DR 5579

May 23, 1973

Mr. F.E. Kruesi
Director of Regulatory Operations
United States Atomic Energy Commission
Washington, D.C. 20545

RUPTURE OF MAIN STEAM SAFETY
VALVE PIPE NOZZLENOTE

Figure 1. Main Steam Piping System

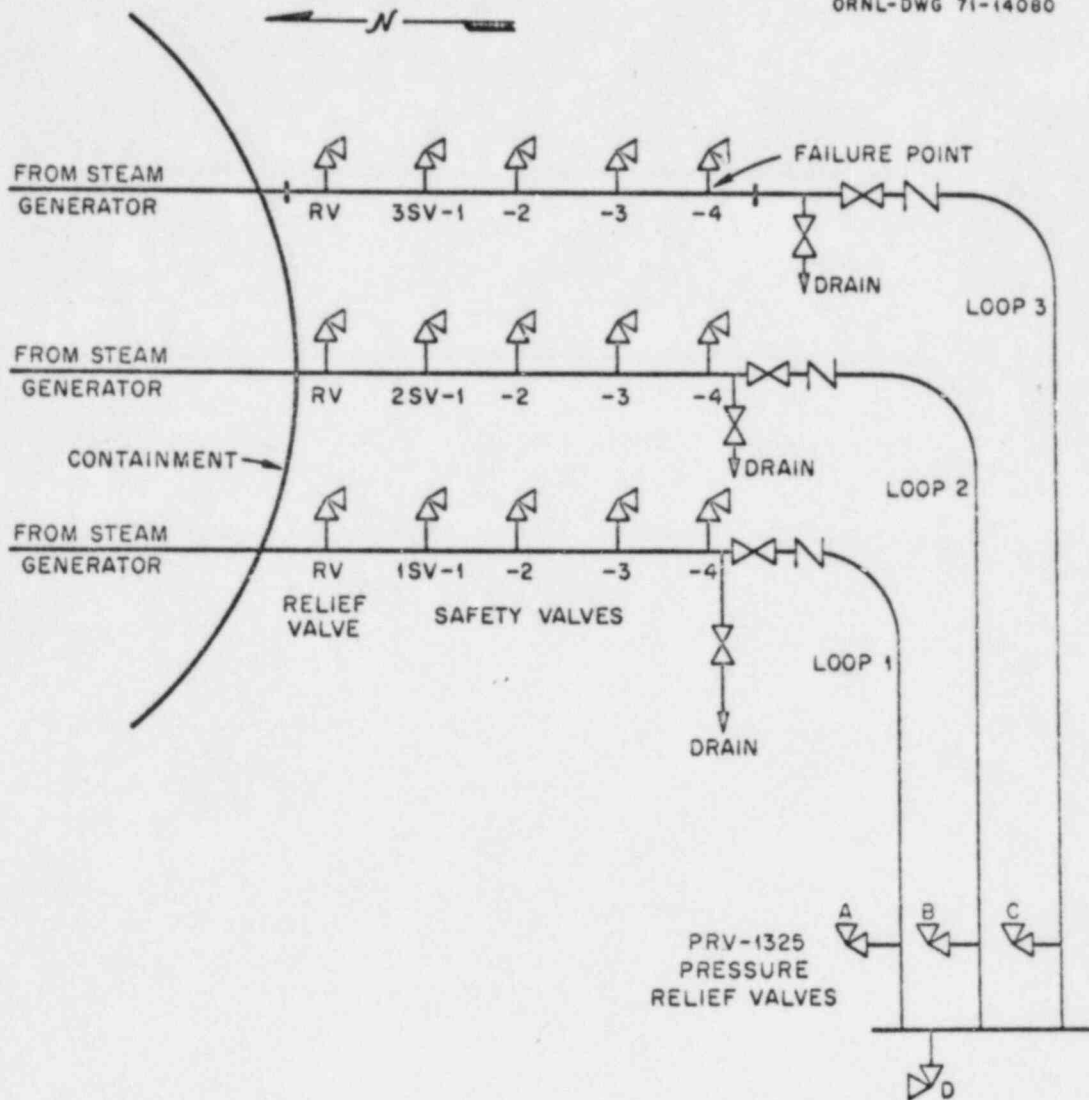
1. Original Safety Valve Headers were dangerous.
2. Replacements are also hazards.
3. Headers were not necessary. No explosion could have occurred in non existant headers.

J.C.H.-- The piping included undesirable features which multiplied the destructive forces. Those features were unnecessary The shear diagrams confirm.

The report indicates that all fractures started near welds. No explosion could have occurred in the safety valve piping if none existed!

The destructive force was the result of piping design which resulted in shear and tensil and Tortion Stresses multiplied by reaction of Safety Valve discharge forces and vibration.

Figure 2. Safety Valve Connection

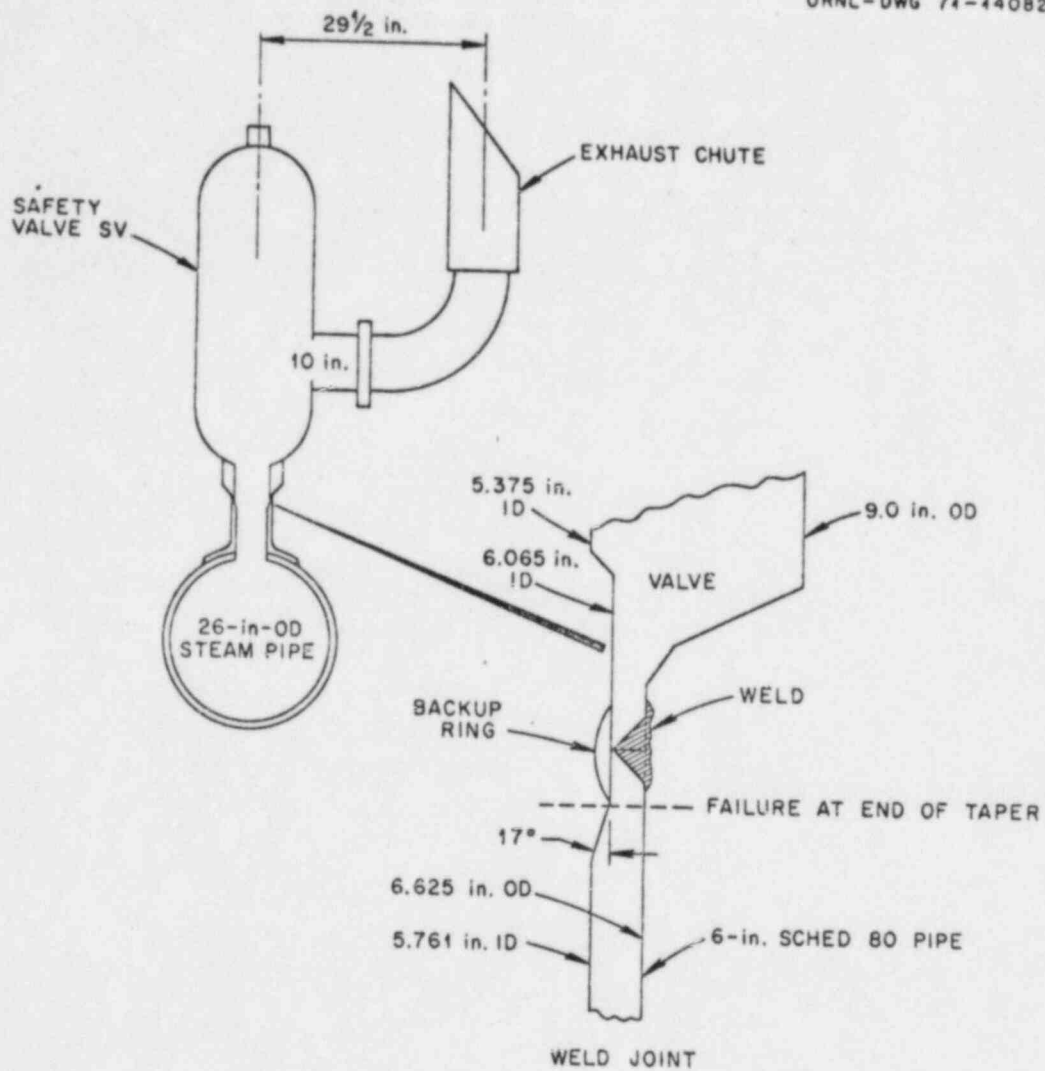
A. "26" main steam piping O.D. and I.D.

B. The Reducers from 26" to 12" and 12" Cap. The original reduction was reported to be 20" to 16" saddle and 16" to 12".

D. Safety Valve -- Original was 4" _____ #Std. _____ #Bolted Flange.

E. The Safety Valves described seem to be unsatisfactory. Mountings created objectionable stresses.

Great weight about 300# for Original and 400# for each of replacements. Drawings of the Original and Replacement Valves could be helpful.

F. Welding design procedures and heat treatment could have been factors. Better practice would have reduced the Stresses to absolute Safety.

G. None of the "repairs" take care of the thermal stresses which caused the violent explosion.

The replacement was said to be 5" _____ #Std.
